<b>Permit Type</b> Building/Residential/Misc/Deck	<b>Permit Number</b> B25001090	<b>Opened Date</b> 03/24/2025
<b>Description of Work</b> SFD/ CONSTRUCT L-SHAPED 36' X 36' DECK WITH STEPS **SUBJECT TO FIELD INSPECTION**

825001090  
 (36L x 12W Deck)  
 Site plan approved  
 4.2.25

**From:** Oswald Jr, Woodin  
**Sent:** Wednesday, April 2, 2025 11:48 AM  
**To:** Gill Gawthrop  
**Subject:** RE: B25001090\_14401 Howard Road  
**Attachments:** as built\_250402\_114500.pdf

PLAN  
 SCALE: 1" = 30'

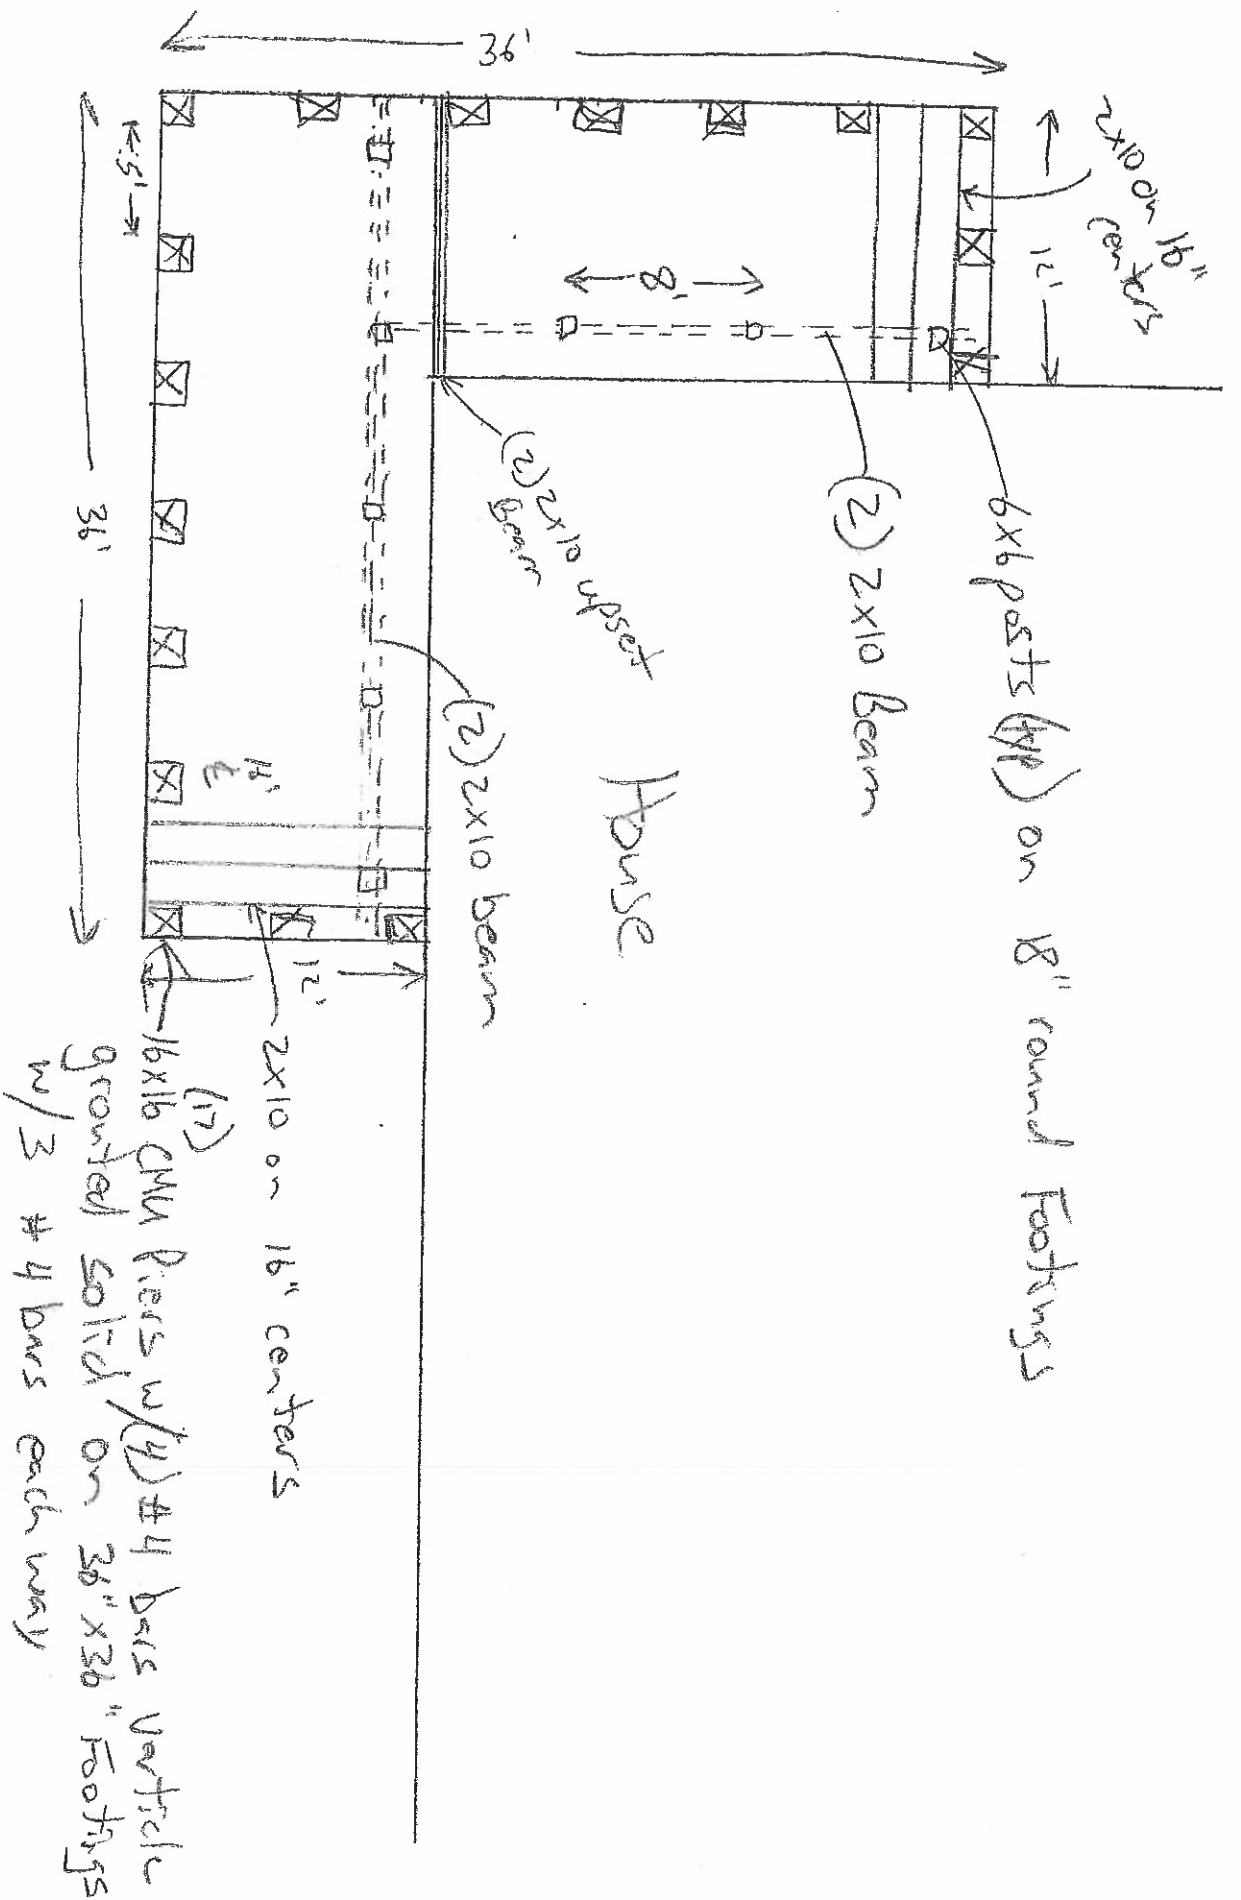
Good morning. I have a couple question regarding the deck dimension. What is the width of the deck? What is the distance between the corner of the existing covered porch and the outer corner of the proposed deck? I need to confirm a minimum 5 foot separation between the existing septic tank and proposed deck.

Thanks for getting back to me. It looks like there will be a 10 ft separation between the existing septic tank and outer corner of the proposed deck, so that's good. It's meets the 5 ft minimum setback distance. I will approve the building permit based on this information, and the as-built drawing (see attached).

The deck is 12 feet wide, off the house. The distance from the corner of the house/ inset porch to the outside corner of the proposed deck is 16 foot 10 inches.
